The Fitzroy Park Residents' Association

RE: APPLICATION NO: 2016/3252/P – 4 THE HEXAGON, FITZROY PARK, N6

Slope down from Fitzroy Park to the development site to the rear right.

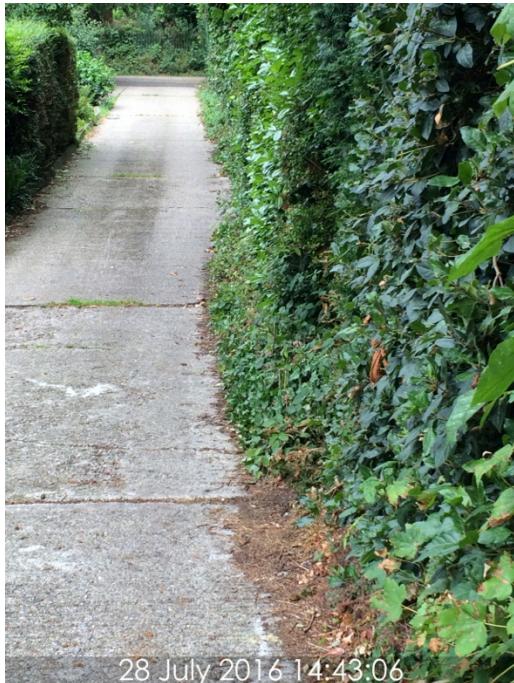
10. The Applicant has failed to provide a Swept Path Analysis showing any of the 1000 HGV movements reversing downhill along the length of Hexagon past a 2.8m wide pinch-point adjacent to a Category A Sweet Chestnut (T21) where it should be noted there will be less than 20cm clearance on each side of the HGV, or exiting uphill along the Hexagon past this pinch point towards Fitzroy Park. It should also be noted that each HGV movement will impact tree foliage along the length of the Hexagon.
